RENEW
Northeast

Offshore Wind Capital Costs for ORTP Calculation: A Proposed Amendment

Abby Krich and Alex Worsley, Boreas Renewables LLC
NEPOOL Markets Committee
September 8-10, 2020

Publicly Available Offshore Wind Capital Cost Estimates

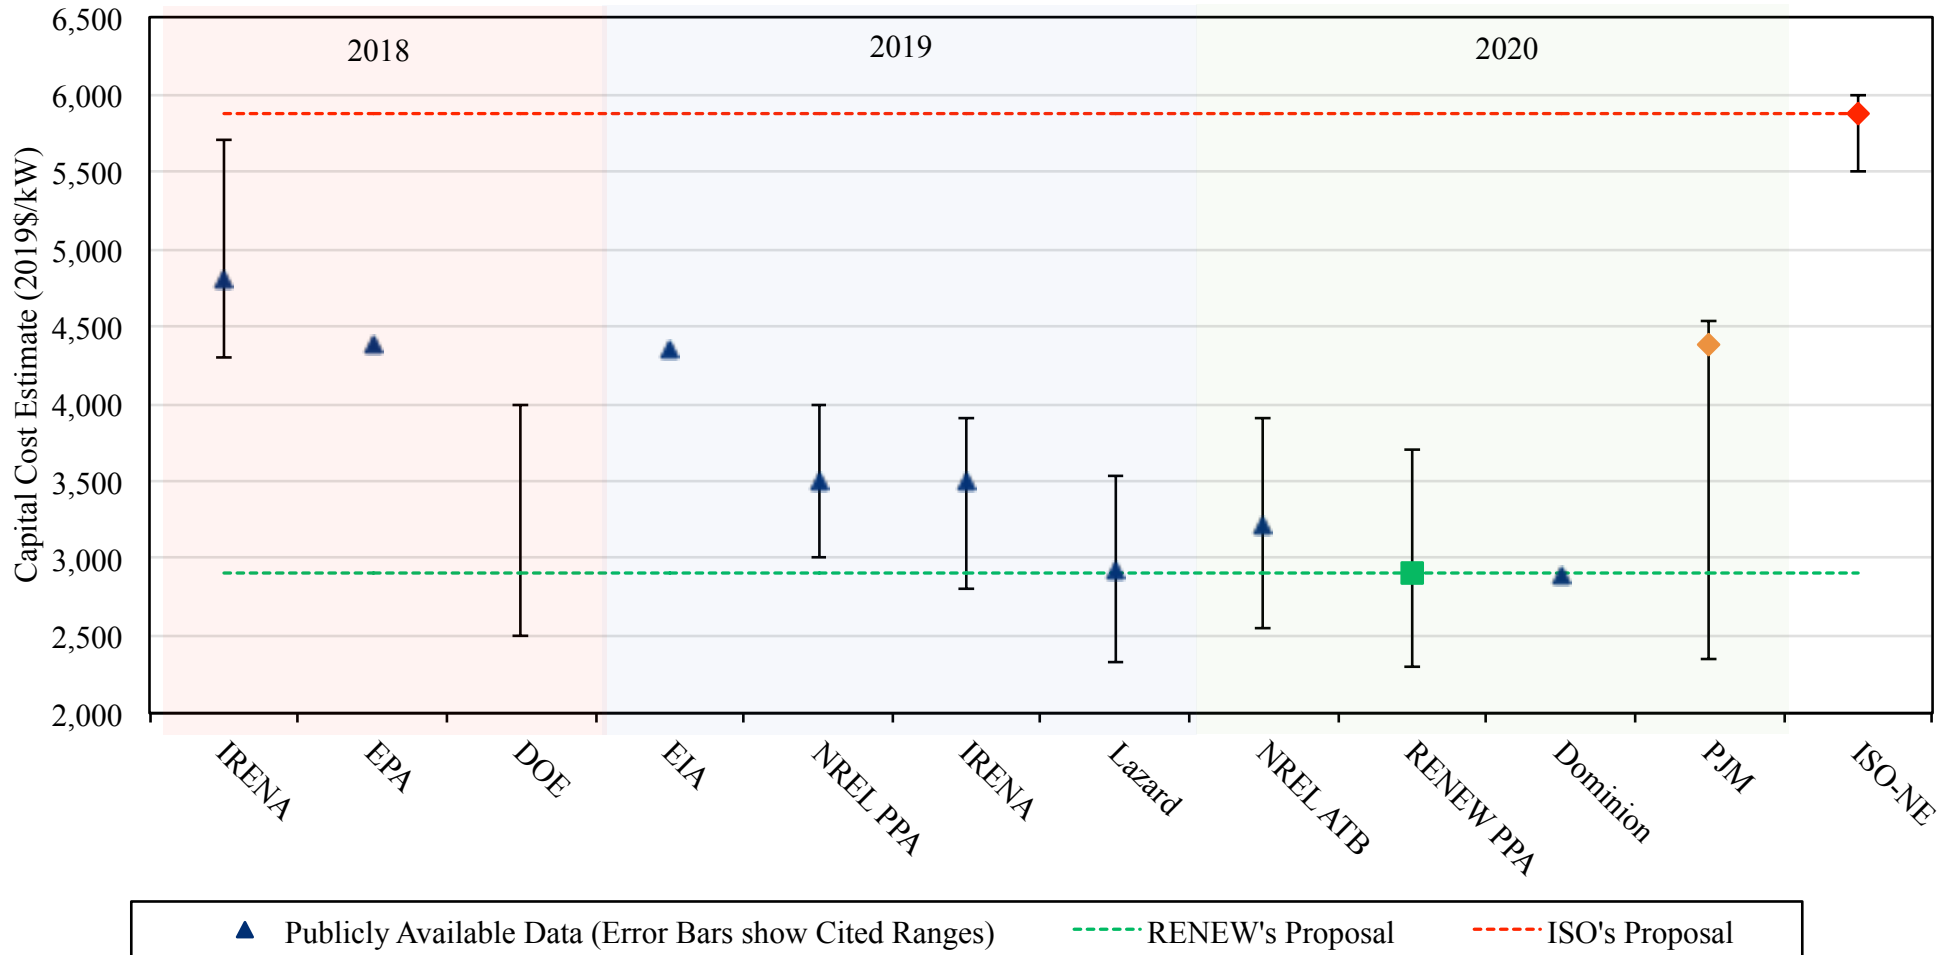
RENEW has primarily looked to two top-down methodologies for benchmarking ISO's capital cost assumption.

- RENEW has looked at a wide range of sources to gauge industry expectations for capital costs both globally and in the United States (NREL, Lazard, DOE, IRENA, EPA, EIA, Dominion, and PJM)
- While any one of these numbers should not be explicitly used in ISO's calculations, they provide a benchmark for the reasonable range of where the final value should land
